DART AEROSPACE LTD	Work Order:	105914
Description: Crosstube Assembly (205/212/412 High Fwd)	Part Number:	D212-664-141
Inspection Dwg: D212-664-141 Rev: D		Page 1 of 2

DRAWING NO. D212-664-141	TITLE XTUBE ASSY (205/212/412 HI FWD)	REV. D	DART AEROSPACE LTD ENGINEERING ORDER		D.E.O. NO. D212-664-141-D-1	SHEET NO. SHEET 1 OF 2	SCALE NTS
DRAWN	CHECKED	MP	MFG. APPR.	APPROVED	MP	DE APPR.	
DATE 11.04.07	DATE 11.04.11		DATE 11.04.12	DATE 11/04/12		DATE 11.04.12

DRAWING NO. D212-664-141	TITLE CROSSTUBE ASS'Y (205 HI FWD)	REV. D	DART AEROSPACE LTD ENGINEERING ORDER		D.E.O. NO. D212-664-141-D-2	SHEET NO. SHEET 1 OF 1	SCALE NTS
DRAWN <i>UP</i>	CHECKED <i>ASS</i>	MFG. APPR. <i>AB</i>	APPROVED <i>MP</i>		DE APPR. <i>HH</i>		
DATE 11.07.15	DATE 11.07.20	DATE 11.07.21	DATE 11/07/21		DATE 11.07.21

DRAWING NO. D212-664-141		TITLE XTUBE ASSY (205/212/412 HI FWD)		REV. D		DART AEROSPACE LTD ENGINEERING ORDER		D.E.O. NO. D212-664-141-D-3		SHEET NO. SHEET 1 OF 1		SCALE NTS	
DRAWN AJS		CHECKED 4P		MFG. APPR. 140		APPROVED 140		DE APPR. 141					
DATE 12.06.28		DATE 12.07.05		DATE 12.07.05		DATE 12.07.05		DATE 12.07.05		DATE 12.07.05

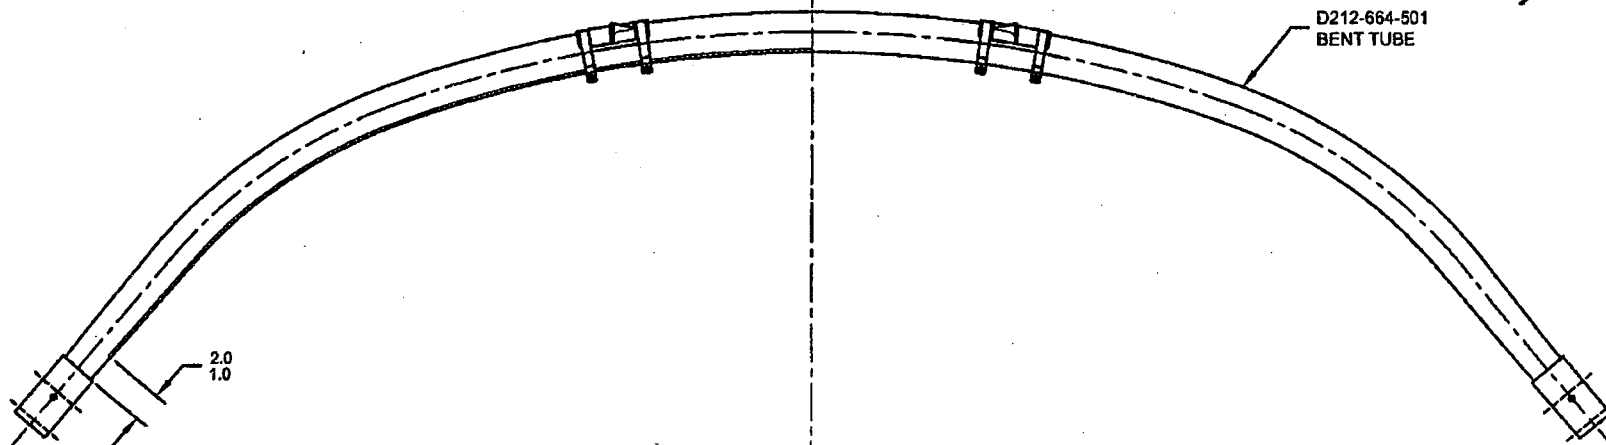
ADD AN INSPECTION WINDOW TO UNDERSIDE OF CROSSTUBE.

MASK AREA PRIOR TO PAINTING,
REMOVE MASKING AFTER PAINT
AND APPLY CLEAR COAT

- 2) FINISH: CHEMICAL CONVERSION COAT PER DART QSI 005 4.1
PRIME INSIDE AND OUTSIDE PER DART QSI 005 4.2
MASK UNDERSIDE OF CROSSTUBE AS SHOWN (HATCHED AREA) AND
PAINT OUTSIDE PER DART QSI 005 4.2
REMOVE MASKING AND APPLY CLEAR COAT
